**CALIFORNIA COASTAL COMMISSION**

**PERMIT AMENDMENT**

**Application Number**.....3-84-139-A1

**Project Description**..... Amend hotel, retail, and parking project approved in 1984, to reduce hotel rooms from 212 to 208, to increase meeting room area from 1,450 sq. ft. to 10,200 sq. ft., to reduce restaurant seats from 200 to 95, to increase retail area from 13,920 sq. ft. to 18,581 sq. ft., to increase parking from 263 spaces to 273, and to amend public access provisions and revise exterior design.

EXHIBIT NO. 5  
 APPLICATION NO.  
 3-84-139-A1  
 California Coastal Commission

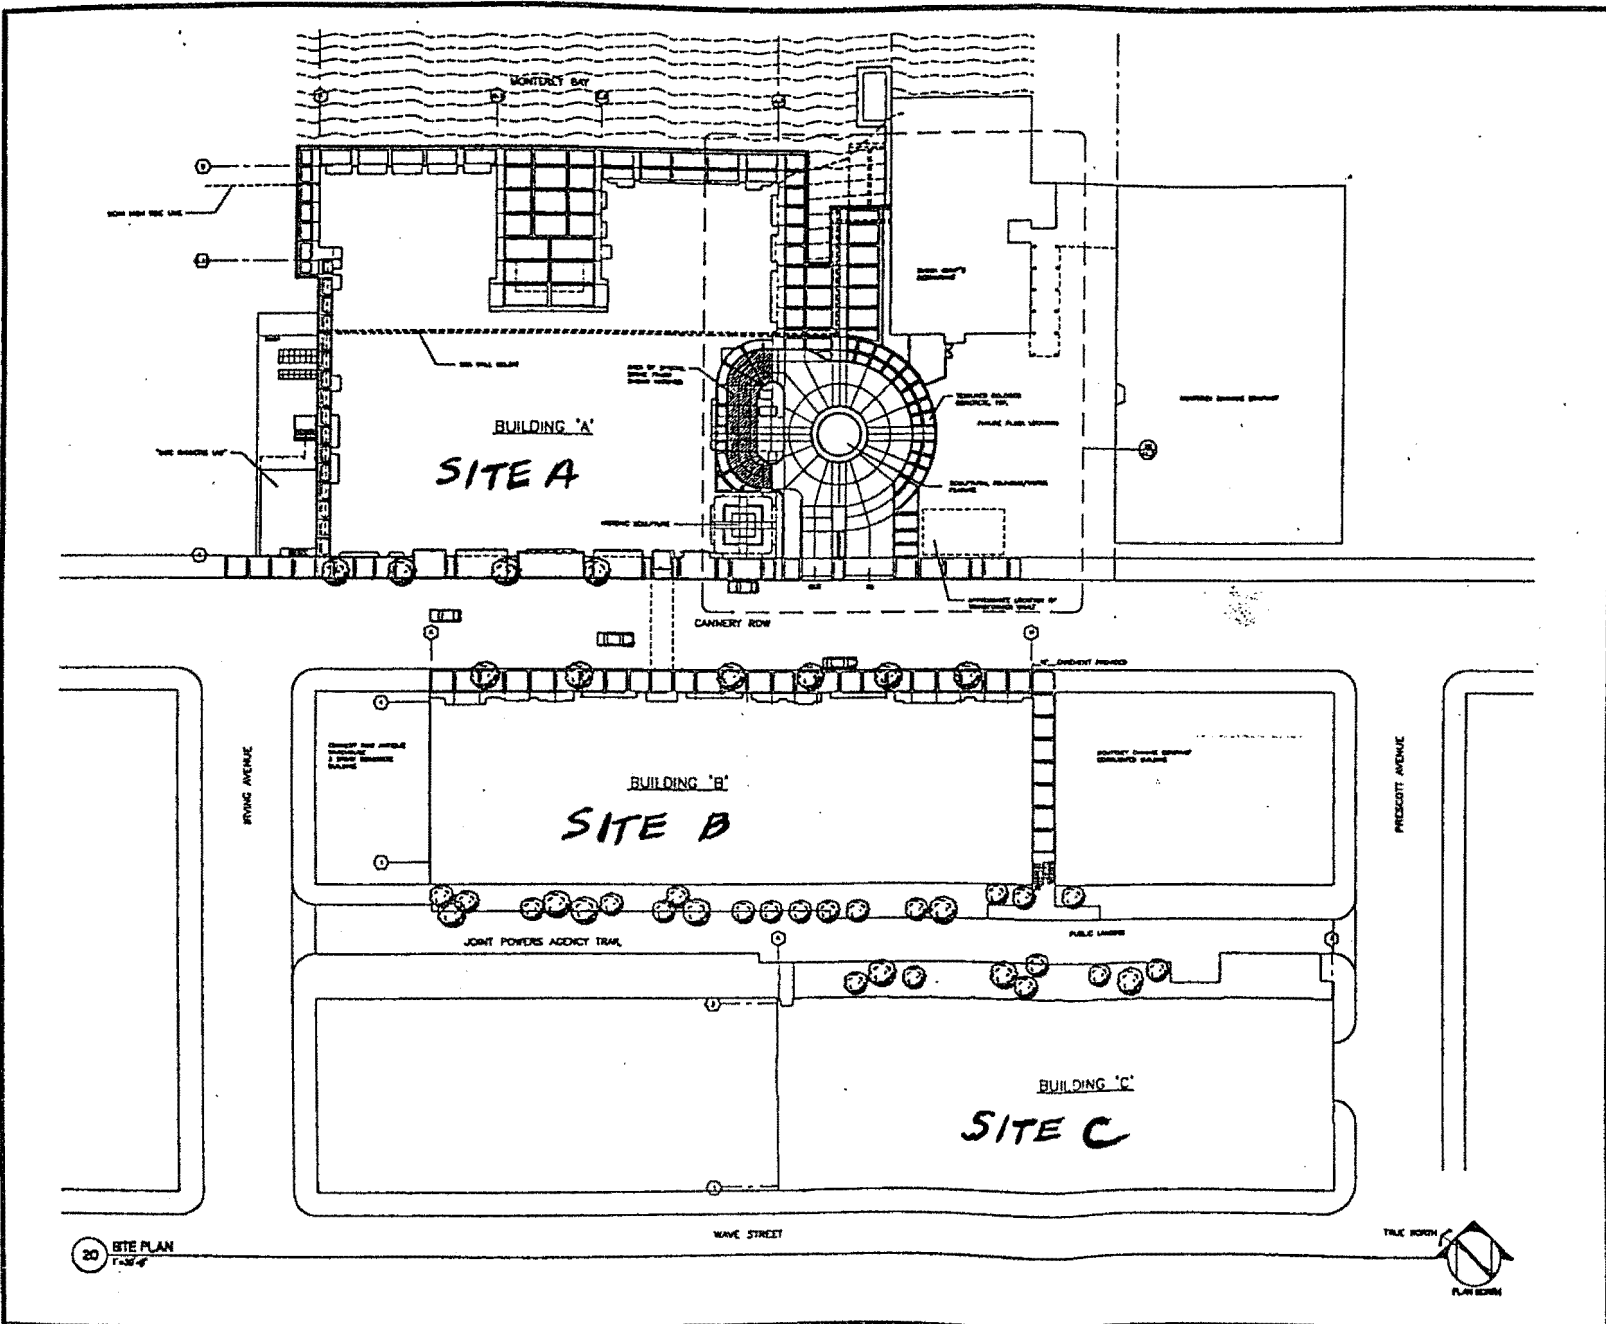
The proposed amended project remains in three buildings but the space would be reconfigured as follows: 208 hotel rooms, 10,200 sq. ft. of meeting room area, 95 restaurant seats, 18,581 sq. ft. of retail space, and 273 parking spaces (Exhibit 4). As in the original plan, Site A will contain hotel rooms, meeting space, retail space, and a restaurant/lounge. Site B will no longer contain parking space on the ground floor – this instead will be converted to additional retail space, with hotel rooms above. Site C remains a parking garage (Exhibit 5).

- a. no further seaward encroachment of building A than that shown in the submitted plans dated November 22, 2000 and prepared by the Ratcliff Architects;
- b. detailed floor plans which specify all the various uses of the hotel (meeting room space, guest rooms, restaurant space, retail space, lobby space, service areas, kitchen, etc.).

EXHIBIT NO. 13
APPLICATION NO.
3-84-139-A7

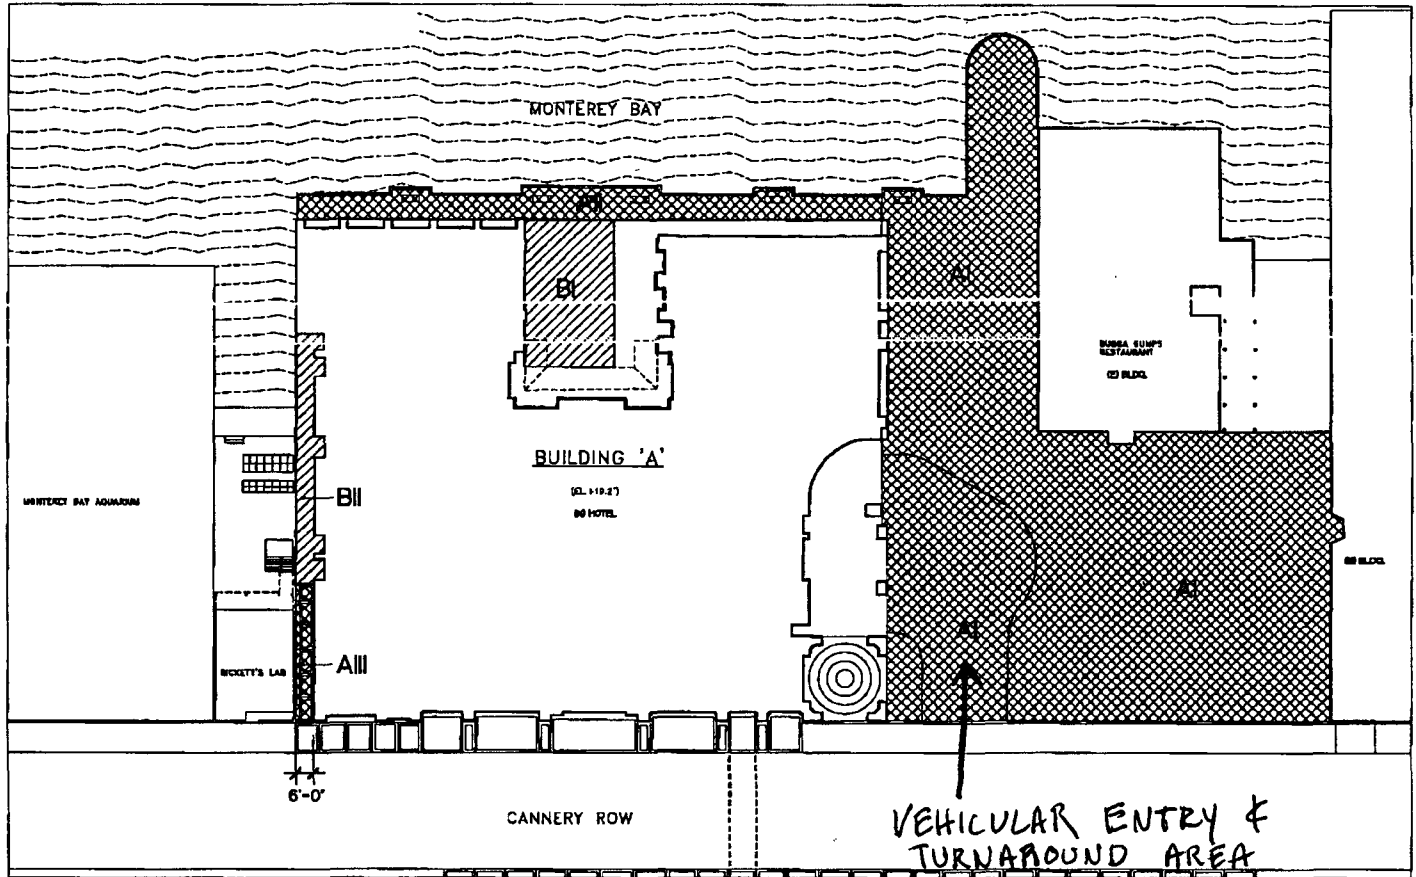
According to the applicants' proposal, approximately 1,500 square feet of the courtyard will be available for public access (B1 in Exhibit 13). This access will be restricted to those days and times when the area is not used for hotel functions. The applicants state that hotel functions will take place in this courtyard up to a maximum of 222 days per year. Given this 222-day figure and the fact that hotel functions are not likely to be held in the courtyard during inclement weather, it is likely that the courtyard will be "roped off" for hotel functions during portions of most fair-weather days. Therefore public access to the courtyard would be most limited on the days in which the public would most likely desire this access, i.e. days with good weather. Also, on days during which multiple hotel functions take place in the

In summary, the project approved in 1984 provided for significant public access improvements, including use of the entire city-owned parcel for passive public recreation and access and an 8-foot accessway along the bayside of the hotel. The proposed plan uses a sizeable portion of the publicly-owned parcel for vehicular access to the hotel. The applicants have proposed other "new" access areas to compensate for the loss of exclusive public access on the city-owned parcel. According to the applicants, this "new" access would increase public access space by 87% compared to the Gin Wong plan. However, the plaza in front of Bubba Gump's Restaurant and the parcel at McAbee Beach already are accessed by the public and as such are not "new," although the proposed improvements to the McAbee Beach parcel, including direct access from the street to McAbee Beach, would benefit the public. Also, the plaza in front of Bubba Gump's Restaurant does not directly access the bayside, nor does the alleyway (AIII) adjacent to Doc Ricketts' Lab. In addition, public access of the courtyard will be limited by hotel functions. The only completely new access areas available daily without

- c. a site plan showing the lateral and vertical access along the bayside and west side of Building A (AII, AIII, and BII in Exhibit 13). The vertical access on the west side of Building A shall connect to the lateral access on the bayside of the hotel. These accesses shall be a minimum of 8 feet in width, excluding the portion of the vertical access labeled AIII in Exhibit 13, which shall be a maximum of 6 feet in width, and BII which shall be from 6 to 8 feet in width. The site plan shall detail improvements, including benches and waste receptacles.

Therefore, in order to adequately compensate for the loss of exclusive public access due to the vehicular turnaround area, in addition to the applicants' proposed access areas, the hotel will be required to provide an 8-foot public walkway adjacent to Doc Ricketts' Lab that connects to the oceanfront walkway, as stated in condition 3c. This represents approximately 900 sq. ft. of additional unrestricted access walkway area. This walkway will remain open from 8:00 a.m. until one hour after sunset. The applicants had not included this walkway primarily because it would reduce the size of their oceanfront meeting room, which they need to be as large as possible for the hotel to be operationally effective and financially viable. Also, the applicants had proposed to use the larger portion of the Doc Ricketts' alleyway (BII) as a service and staging area for the hotel's two main meeting rooms. To keep the oceanfront meeting room at its proposed size and to allow for a service corridor, the meeting room wall adjacent to the courtyard could be shifted into the courtyard. To maintain courtyard space, the courtyard wall adjacent to the restaurant could be shifted into the restaurant. The proposed restaurant is 3,906 sq. ft., which is a very large space for a 95-seat dining room (the kitchen facilities are located in the basement). The restaurant area could be reduced by the square footage necessary to accommodate the walkway and the service corridor, and still be adequate to house 95 seats. Therefore, the walkway and service corridor can be accommodated without any loss in meeting room space or in courtyard space. Another option is to cantilever over the water the portion of the walkway that is adjacent to the oceanfront meeting room. This would reduce any impact on hotel redesign but would extend over an adjacent property, which is owned by the City of Monterey. It is noted that the City of Monterey, the members of the Pacific Biological Club, and the Historic Preservation Commission have opposed this option in the past, as expressed by the City's Conditions of Approval prohibition (Exhibit 6, #4). However, the previously existing cannery had catwalks in this same area, so there is historical precedent for similar walkway structures behind Doc Ricketts' Lab.

PROPOSED McABEE BEACH IMPROVEMENTS

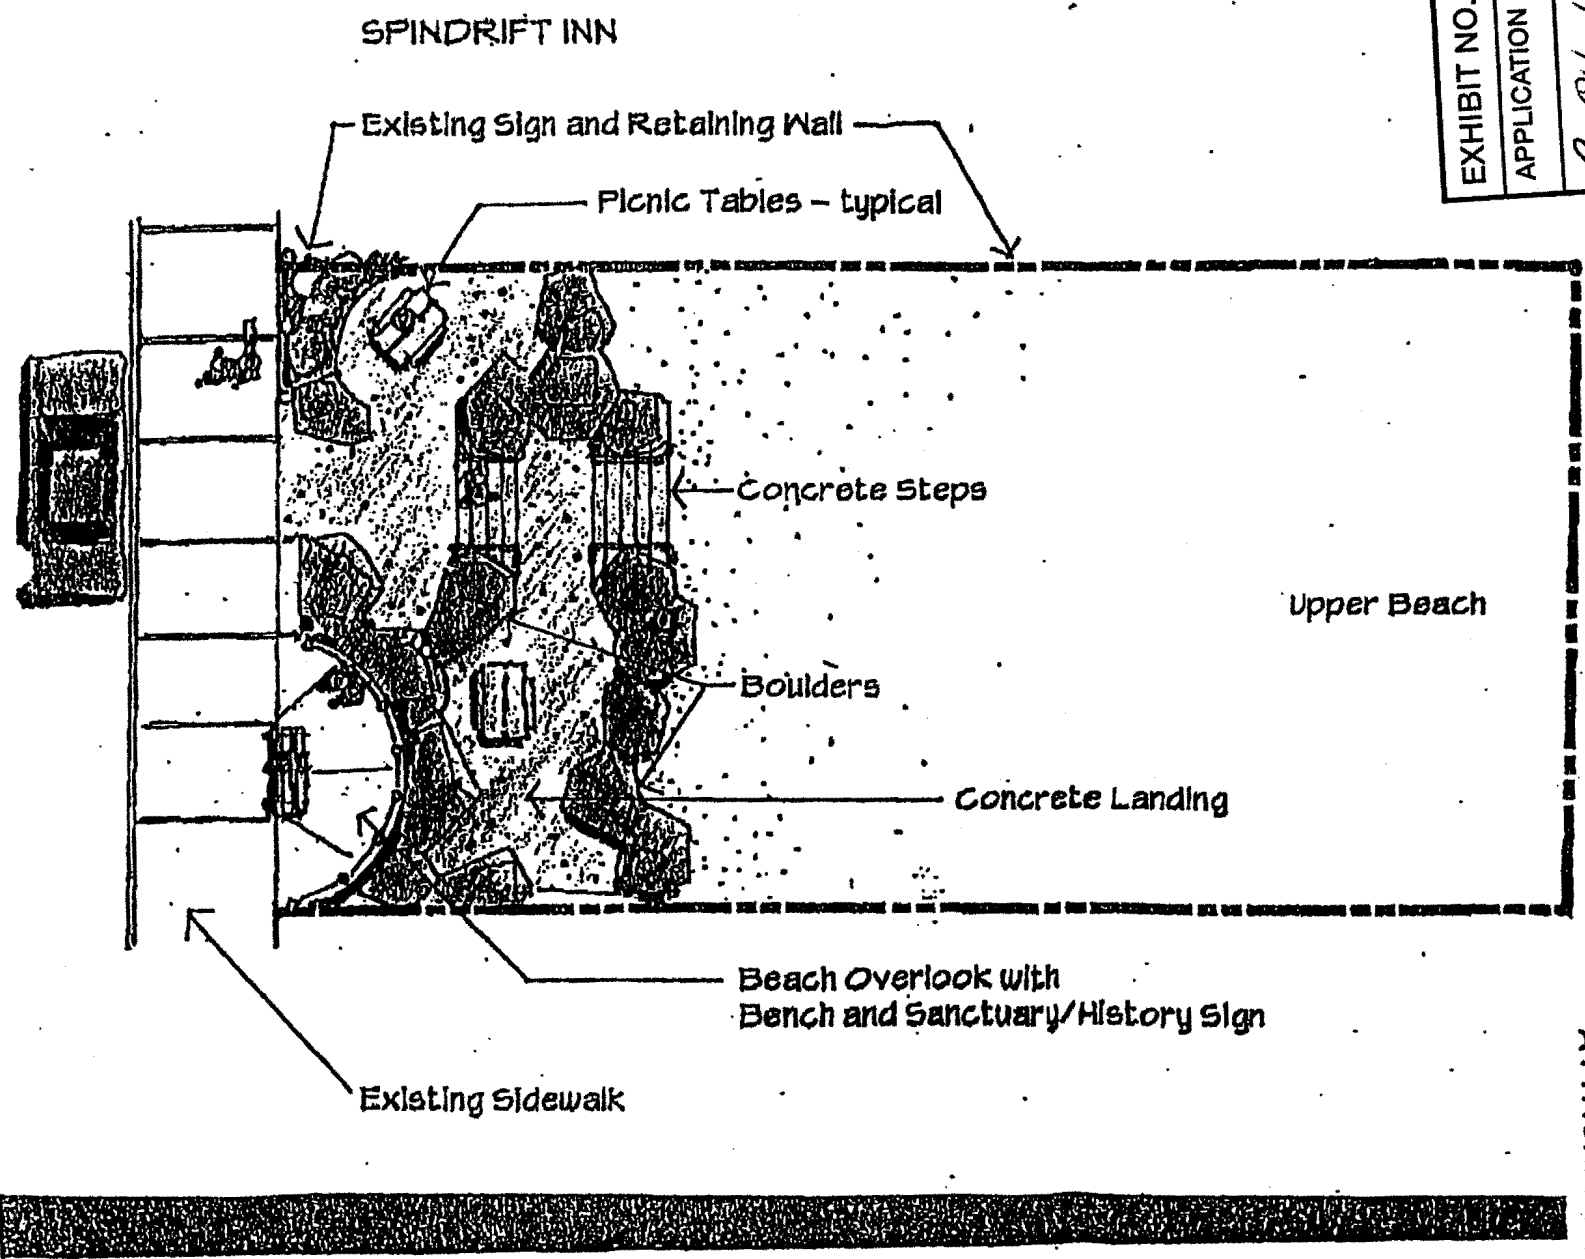
Regarding McAbee Beach, the applicants state that the proposed development of a portion of this beach will create new public access, which was not included in the approved Gin Wong Plan (Exhibit 12). Although the Cannery Row Company owns this property above the mean high tide line, McAbee Beach has been openly and continuously used by the public for many years. A strong case could be made for the establishment of public prescriptive rights on all the sandy beach portions of this beach, given that this beach has been used by the public for many years with concentrated use by the public since the mid-1960's to the present. A five-foot walkway on each side of the Spindrift Hotel provides access to the beach. There is also access from Steinbeck Plaza. Therefore, this is not "new" access, although a portion of the beach near the street will be improved and will be more amenable to public use (Exhibit 14). The Spindrift Hotel currently abuts the portion of the beach that will be improved. The question arises as to how useful this beach access will be if the adjacent larger beach parcel is built upon, leaving a very small section of beach between two buildings. In addition, as proposed, it is not clear how public use of McAbee Beach will be secured or for what time period.

- j. the permittees shall, in cooperation with the City of Monterey, submit to the Executive Director for review and approval a site plan showing the McAbee Beach access and improvements (Exhibit 12).
- k. all access improvements shown on the approved access plan for the hotel and the Plaza del Mar sites shall be constructed and available for public use.
- l. the permittees shall, in cooperation with the City, place public access signs (which conform to the City of Monterey's signage program) at McAbee Beach. Public improvements to McAbee Beach shall be completed consistent with the City of Monterey Parks and Recreation Division's schedule.
